MEMORANDUM

REVIEW TYPE: Pre-Preliminary Plan of Subdivision
Pursuant to Section 50-33 (Non-Binding)

APPLYING FOR: Resubdivision of Existing Lots 40 and 44, Bowie Mills Estates
Subdivision for Four Lots

PROJECT NAME: Bowie Mill Estates

Attachment C NEIGHBORHOOD

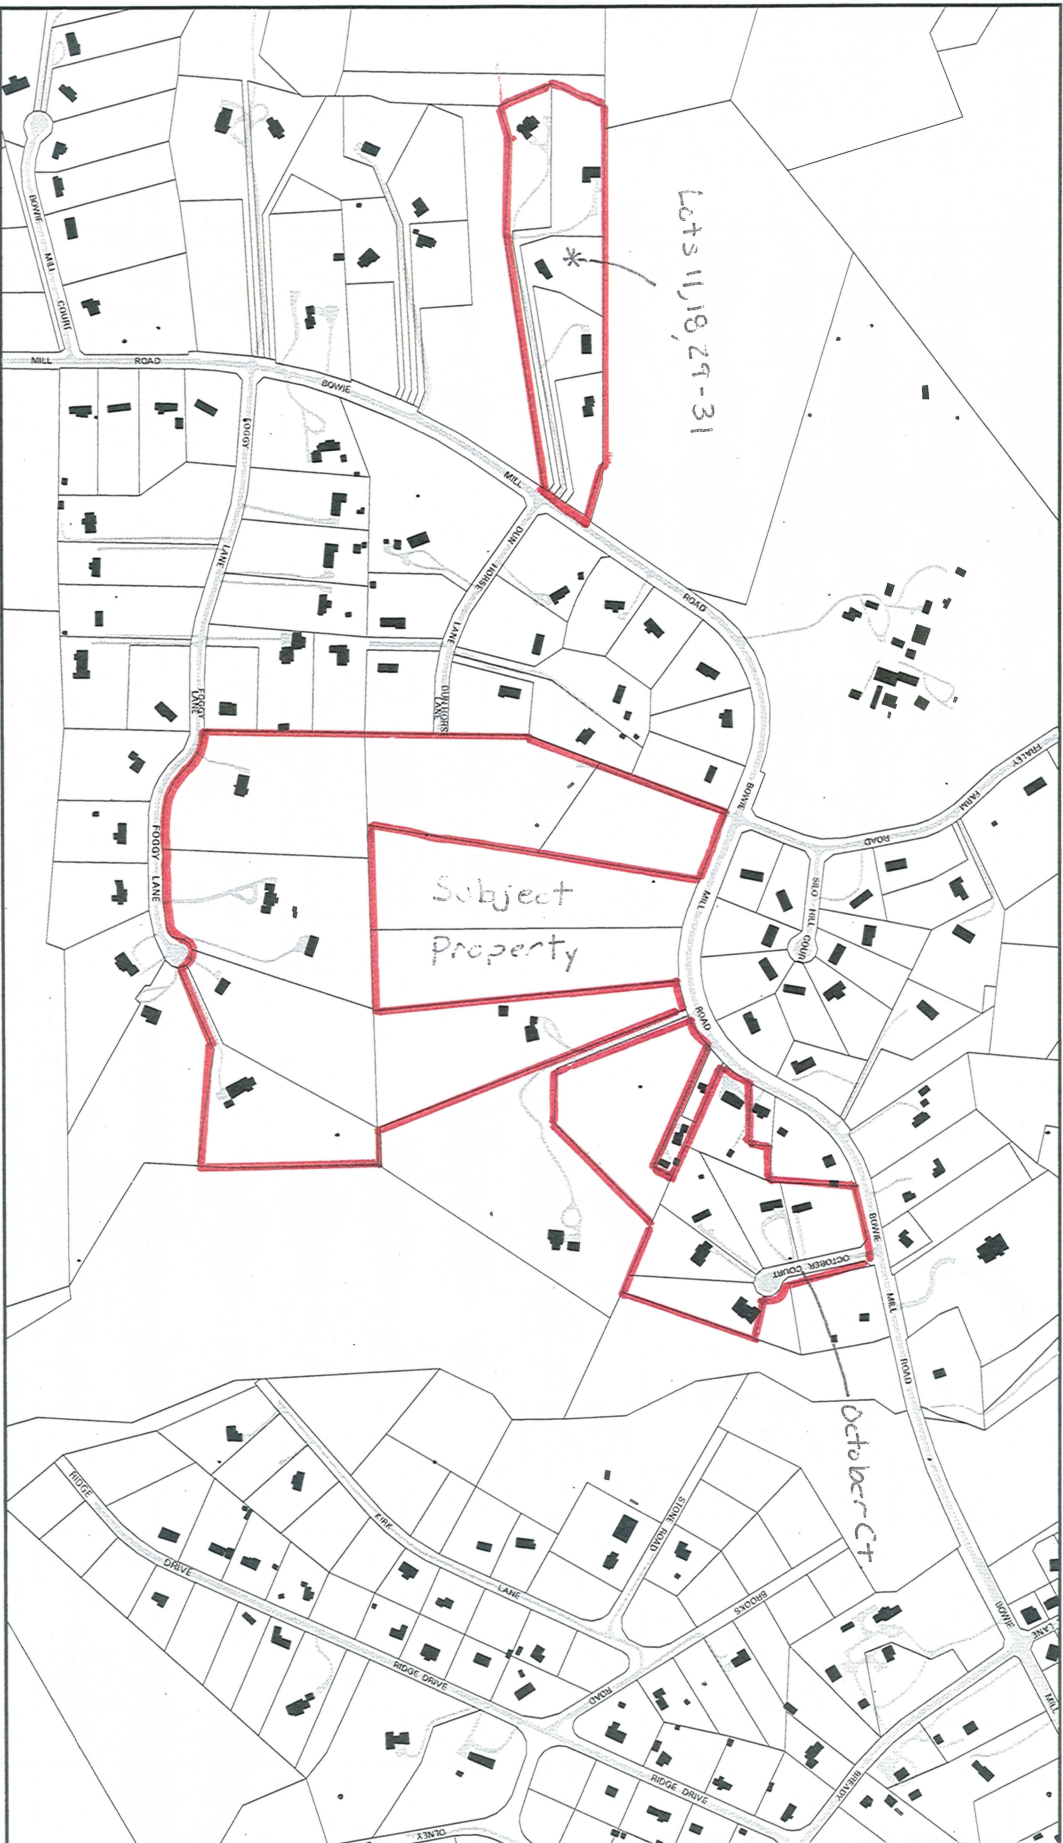
In administering Section 50-29(b)(2) of the Subdivision Regulations, the Planning Board must determine the appropriate "Neighborhood" to evaluate the application. For this application, the applicant submitted a Neighborhood of 19 lots that includes all lots abutting the proposed lots and lots that access Bowie Mill Road within close proximity to the subject property. Lots 2-6 on October Court and Lots 11, 18 and 29-31 with private driveway access to Bowie Mill Road were accepted into the Neighborhood, in part, to provide a sufficient sampling of lots upon which to draw a reasonable comparison of lot characteristics. These lots are also within reasonable distance of the subject property. All included lots are zoned RE-2, as is the Subject Property. Staff and the Planning Board have historically not crossed zoning boundaries when determining the Neighborhood suitable for a resubdivision evaluation. Therefore, the neighborhood excludes lots in the RE-1 zone even though they are confronting the subject property or are within close proximity to the subject property.

In Staff's opinion, the Applicant's proposed Neighborhood is appropriate. It contains an adequate number of lots upon which to compare the requested division of land.
